REQUEST FOR PROPOSAL
Kaysville City Council Chambers
&
Police Department Emergency Operations Center
Audiovisual System Replacement

ADDENDUM NO. 2

RFP CLARIFICATIONS FOLLOWING PRE-PROPOSAL SITE WALK

Existing Hubbell NX lighting control equipment - Photo 1

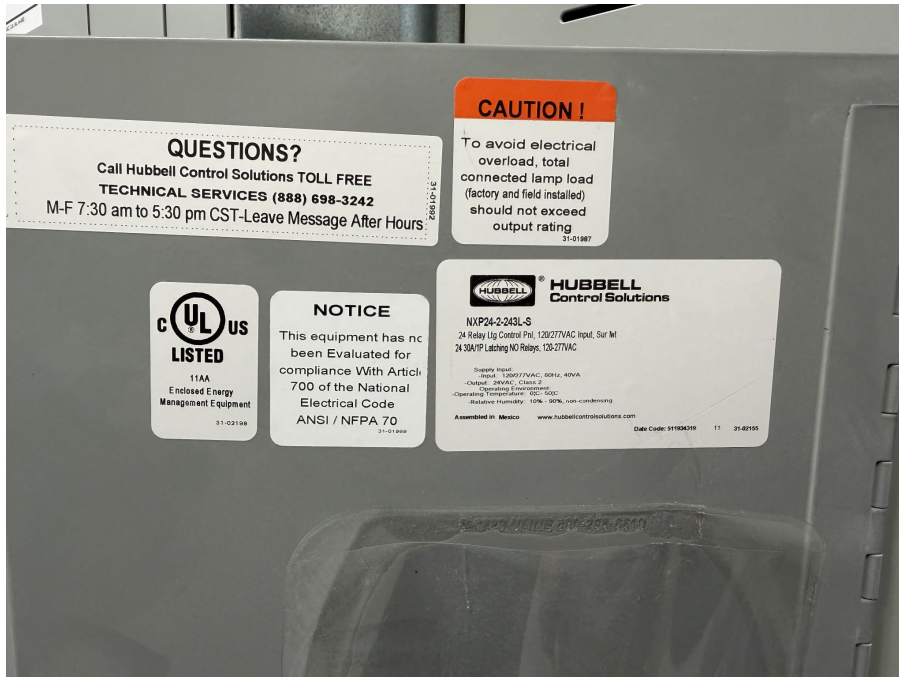
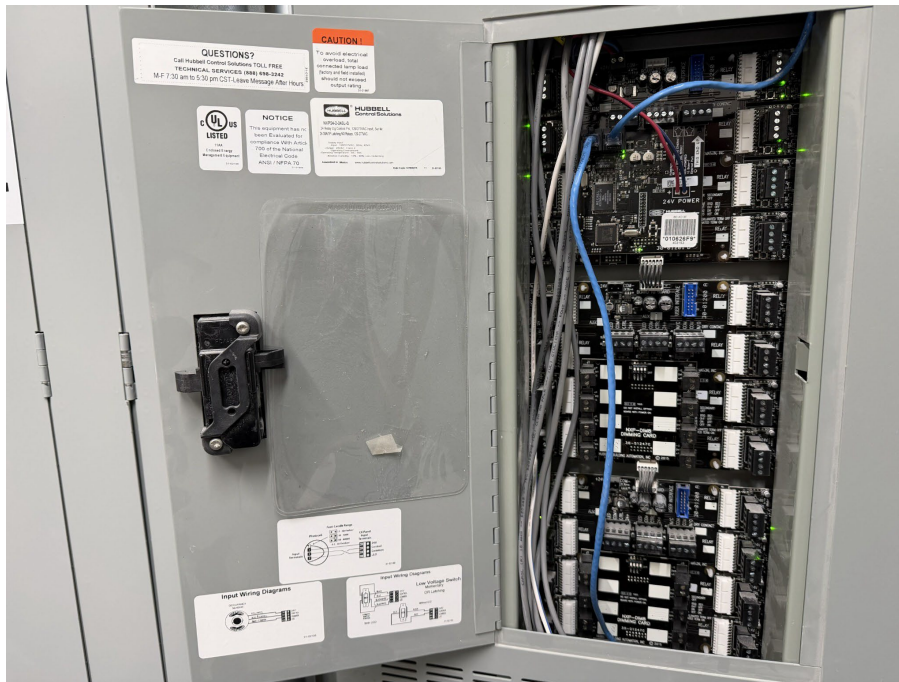
Question 24: What is the manufacturer and model of the existing Council Chambers lighting control system that the AV system will need to integrate with?

Answer: The existing Council Chambers lighting control system is a Hubbell Control Solutions NX Distributed Intelligence system. The equipment identified from the existing installation includes an NX Area Controller, model NXAC-120-001, and a 24-relay lighting control panel, model NXP24-2-243L-S.

The proposed AV system shall integrate with the existing Hubbell NX lighting control system and provide the lighting-control functionality required by the RFP. Proposers are responsible for determining the appropriate method of integration with the existing system.

Existing Council Chambers pre-function/lobby display. Approximate diagonal screen measurement shown for reference.

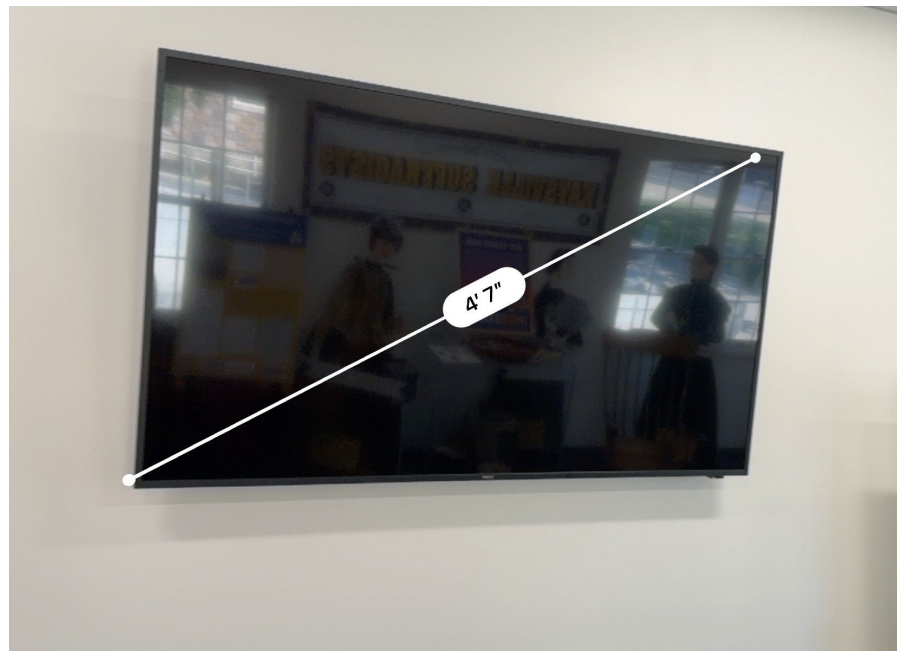
The existing display in the Council Chambers pre-function/lobby area is currently not functioning as intended.

Historically, when the Council Chambers system was in use, the pre-function/lobby display could show the Council Chambers program video with accompanying audio. The system also provided control of the display and audio for that area.

Currently, the display does not provide program video. Audio from the Council Chambers remains available in the pre-function/lobby area, but the complete video and control functionality no longer works.

The replacement system shall restore this functionality. The pre-function/lobby area shall receive the appropriate Council Chambers program video and accompanying audio. The system shall also provide practical control to turn the feed on and off and adjust audio volume for the pre-function/lobby area.

The intent is for individuals in the pre-function/lobby area to be able to see and hear the Council Chambers meeting when desired while allowing City staff to control operation and volume of the feed.
